**PUBLIC COMMENTS AND STAFF RESPONSES
FOR**

**TOTAL MAXIMUM DAILY LOADS FOR NITROGEN COMPOUNDS AND
ORTHOPHOSPHATE FOR THE LOWER SALINAS RIVER AND RECLAMATION
CANAL BASIN AND THE MORO COJO SLOUGH SUBWATERSHED, MONTEREY
COUNTY, CALIFORNIA (DRAFT PROJECT REPORT - OCTOBER 8, 2012)**

Figure 1 Percentage of water quality samples (1999-2010) that are CURRENTLY meeting proposed biostimulatory targets for nitrate.

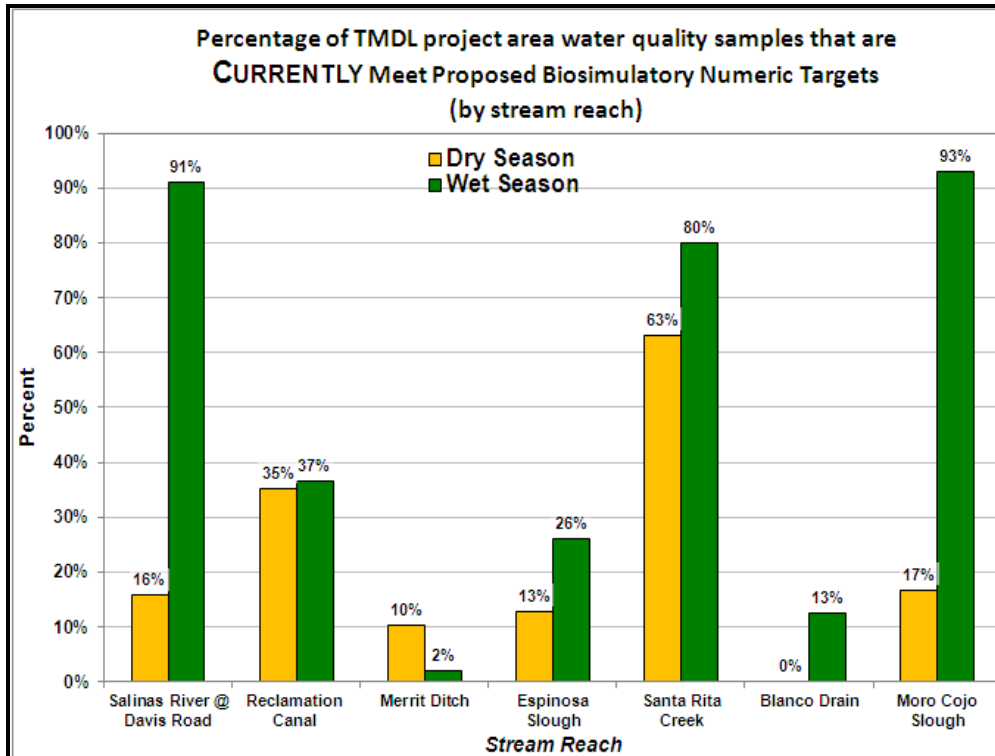
As one of the leading Agricultural organizations in Monterey County, we are expressing concern with some of the provisions of the proposed Total Maximum Daily Load (TMDL) for the Lower Salinas River and other basins listed in this document. Overall, we find that the proposed standards are too aggressive and set up the farming community in these watersheds for ultimate failure when these standards cannot be achieved. Our concern is that while attempting to achieve these standards, farmers will expend huge amounts of capital chasing an unrealistic target. In an age where regulatory pressures from all sides are chipping away at the financial viability of farmers, particularly small farming operations, the targets suggested will exasperate a tenuous situation.

Regarding the comments on the infeasibility of achieving the proposed water quality targets, it is important to note that the approaches staff used in biostimulatory water quality target development were based in part on USEPA-recognized statistical methods. Practically speaking, this means the approach staff employed was intended to facilitate numeric target development appropriate to local scales and local conditions. Since staff's approach included the 25th percentile approach applied at the project-area scale, as a practical matter this means that on average one out of every four (25%) water quality samples (monitoring years 1999-2010) on average are in fact already meeting the proposed biostimulatory targets. In other words, it is not accurate to suggest the targets are infeasible and cannot be achieved – they are already being achieved episodically in many stream reaches of the TMDL project area. It should be noted that achieving the targets in some stream reaches, like Blanco Drain, and Tembladero Slough, will indeed be challenging, either because upstream sources are contributing to the observed in-stream degradation (Tembladero Slough), or because control of shallow groundwater, tile drainage, and water management in a vegetable cropland setting present challenging technical issues locally. Figure 1 presents a graphical illustration of the frequency with which current and recent water quality samples already meet the proposed biostimulatory numeric water quality targets.

Figure 4. Losing stream and gaining stream.

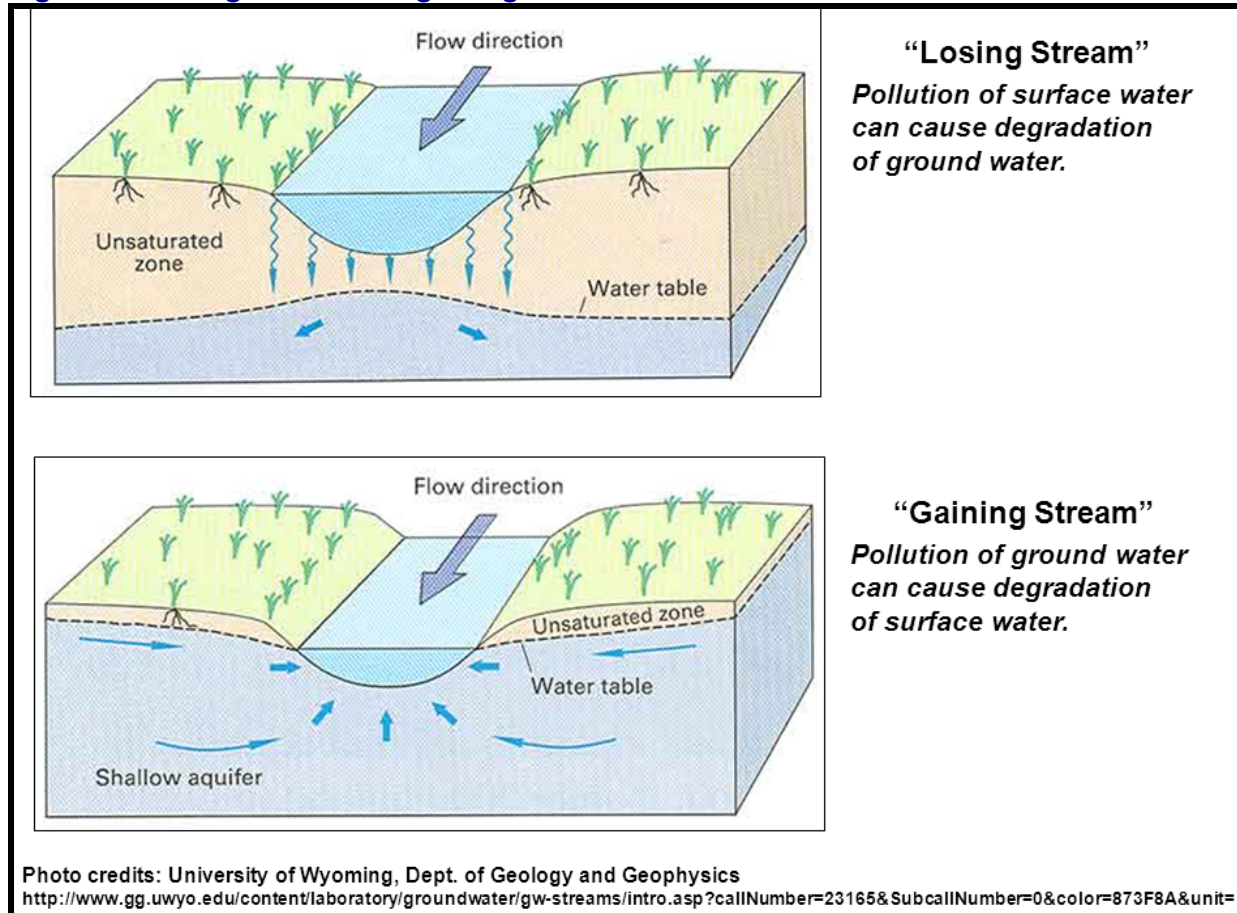
The comparison between agriculture, urban, and undeveloped land has been absent from previous analyses. It would have been helpful if ranges of measured nitrate concentrations were provided to compare to modeled nitrate concentrations. Is it assumed that predicted and estimated nitrate concentrations are the same factor? Also, please note that these figures as well as Figure 2-17 do not include a date or timeframe.

It should noted that some insights on groundwater interactions with streams can be deduced from field observation, and local knowledge of land and stream flow conditions. Gaining streams (those receiving groundwater inputs) would generally be expected to be located in lower reaches of alluvial basin floor areas where perennial flows are observed and local soil conditions and perched or shallow groundwater horizons are known or expected to exist. Headwater and upland reaches are sometimes expected to have gaining stream hydraulics as well. Losing streams (those which percolate to groundwater and do not receive substantial groundwater inputs, particularly in the dry season) would be expected to be associated with intermittent streams located on alluvial fan and alluvial plain geomorphic settings of the project area where high permeability soil and stream substrate conditions exist. These reaches would exhibit intermittent flows or dry stream beds in the absence of artificial return flows. Conceptually, the aforementioned information is illustrated in Figure 4.

Figure 13. Computer screen-capture from October 2012 draft TMDL Project Report-Appendix D: An example of monitoring sites, stream and landscape criteria, and water quality statistics used in derivation of proposed nutrient targets in the alluvial valley basin floor stream category.

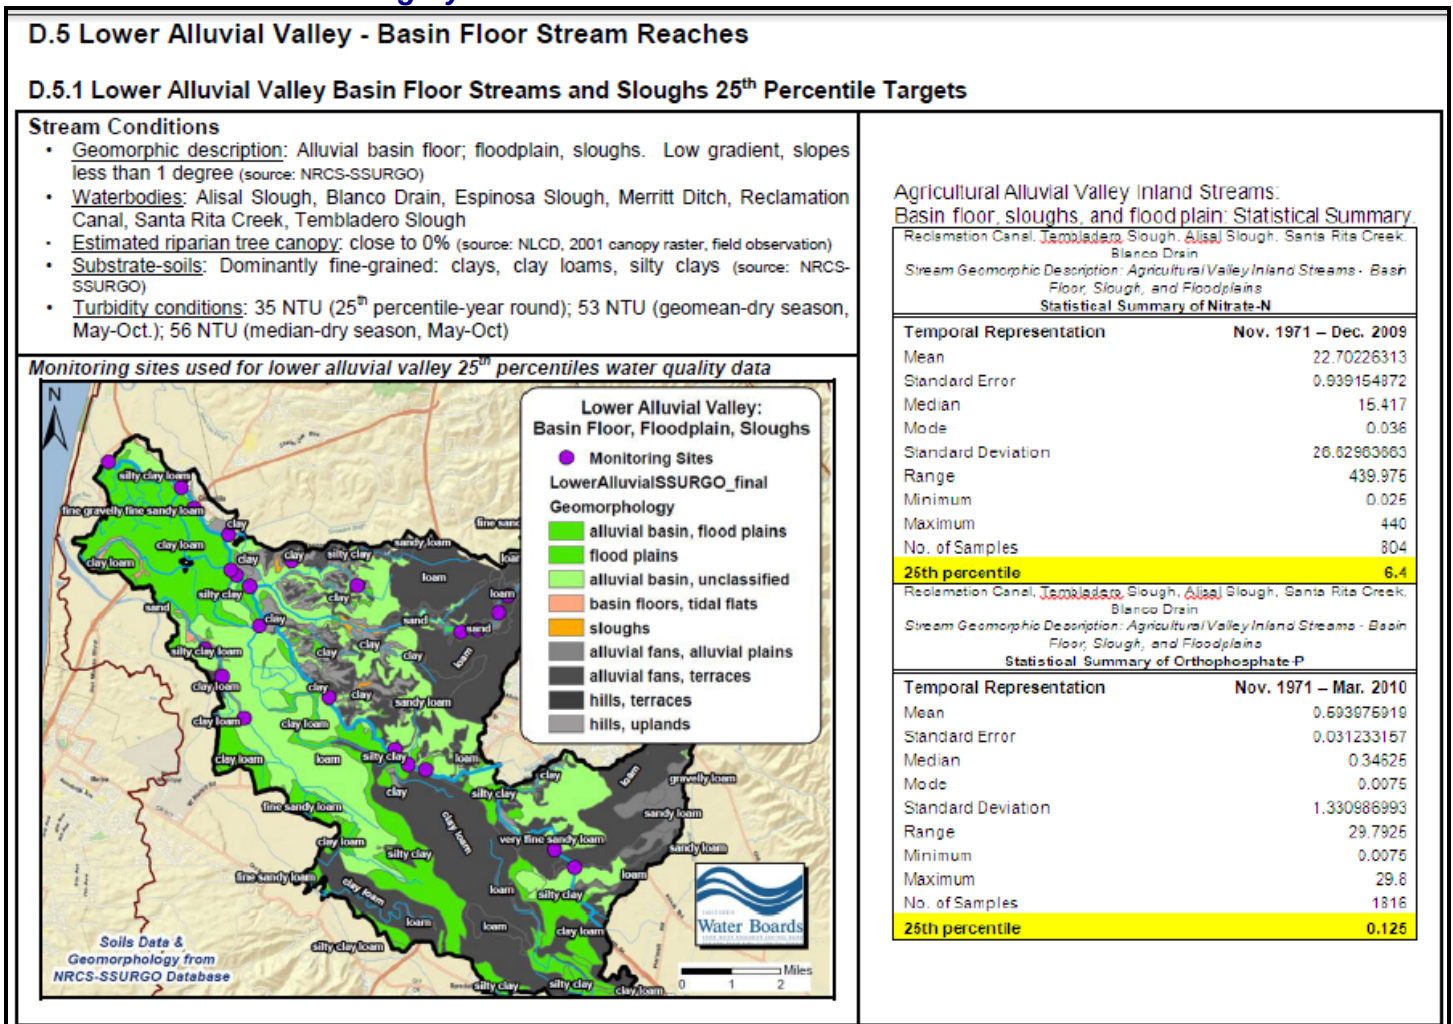
One concern that arises is the appropriateness of using the SWRCB draft Statewide Nutrient Policy recommendations to craft numeric targets in this TMDL. Until this policy is adopted, it is not the controlling guidance, and we recommend that Staff constrain the TMDL to currently adopted policies, procedures, and regulations. Another concern that exists is the use of surrogates for reference stream populations when those surrogates are derived from nutrient ecoregions significantly different from the Salinas Valley. The use of data from Minnesota lakes and Tennessee streams are not appropriate surrogates. We suggest the development of alternative surrogates using locally pertinent data or the abandonment of the use of the 25th percentile surrogates as proposed by the EPA.

Regarding the comment on use of data, staff did not use data from Minnesota Lakes and Tennessee streams. Reference to Minnesota and Tennessee in the October 2012 draft project report was historical references and backdrop pertaining to USEPA's nutrient criteria guidance document. As documented in the October 2012 draft Project Report Appendix D – Nutrient Target development, Staff only used local and TMDL project-area specific data in the derivation of proposed nutrient water quality targets. For ease of reference, a screen capture from Project Report-Appendix D is shown in Figure 13 and provides an example of the monitoring sites, stream and landscape criteria, and water quality statistics for the alluvial valley basin floor stream category staff developed to support nutrient target development.
